SUBJECT: Waiver of Rules for Late Submission of Office of Planning Preliminary Report
Zoning Commission Cases Nos. 03-12 and 03-13
Planned Unit Developments and Map Amendment for
Capper/Carrollsburg Hope VI Revitalization Project

Re: Capper/Carrollsburg Hope VI Planned Unit Development
Zoning Commission Cases No. 03-12/03-13

SUBJECT: Preliminary Report – Zoning Commission Case No.03-12 and 03-13
Planned Unit Developments and Map Amendment for
Capper/Carrollsburg Hope VI Revitalization Project

Attachment 1

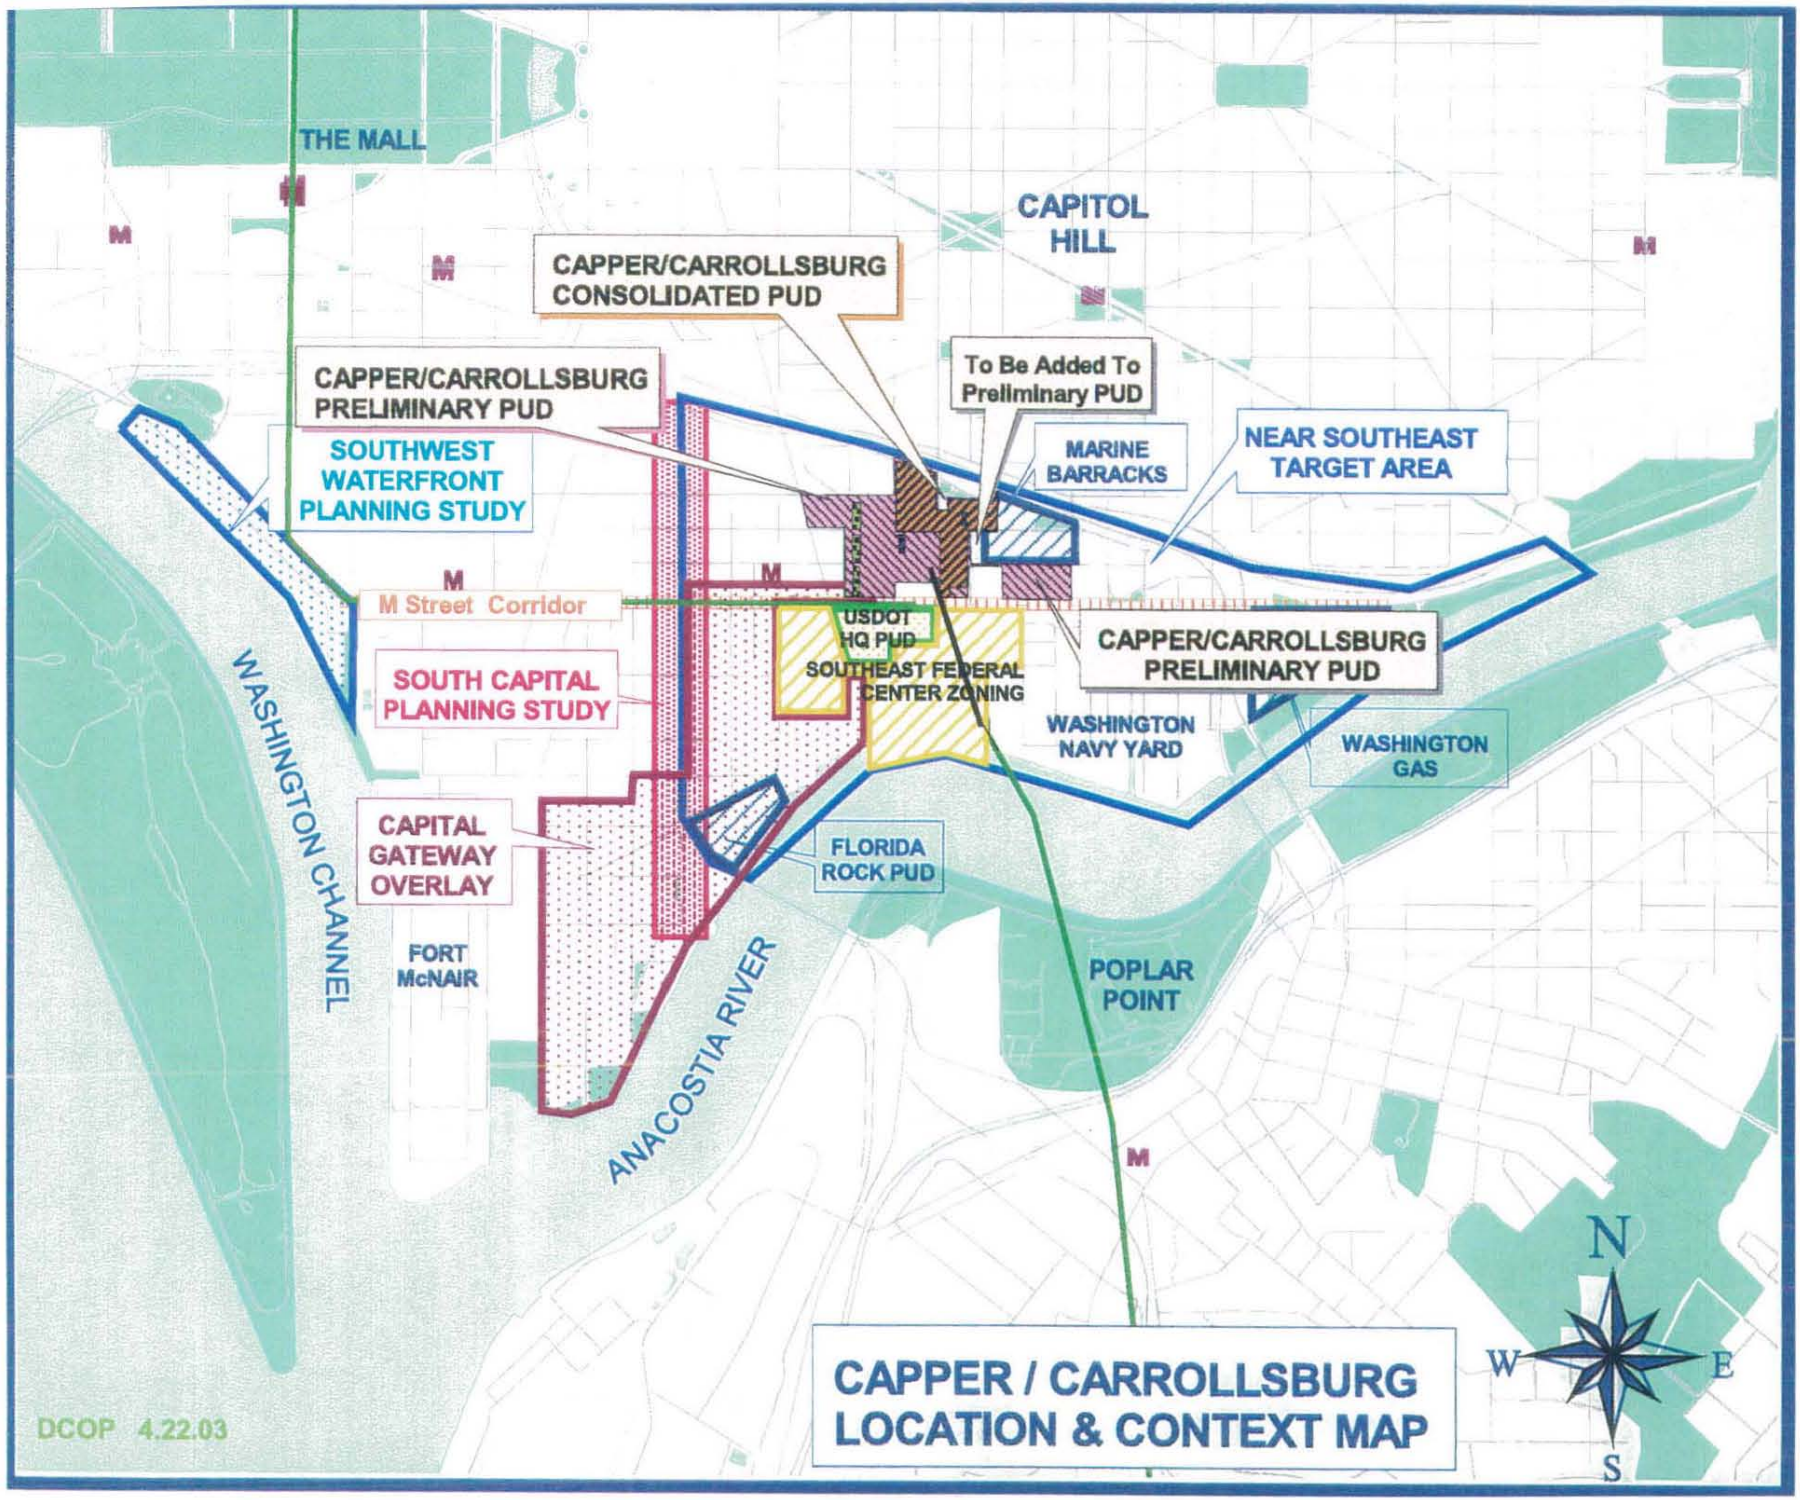
Please note that since the report was written, the eastern boundary of the PUD application has been shifted slightly, at OP's request. A letter from the applicant confirming this adjustment is attached to the report.

- Modification to Eastern PUD Boundary: The applicant has agreed to add the westernmost portion of Square 881to the Preliminary PUD boundary. This area is bounded by 5th Street, K Street, L Street and the western boundary of the property at the Marine Barracks annex garage.
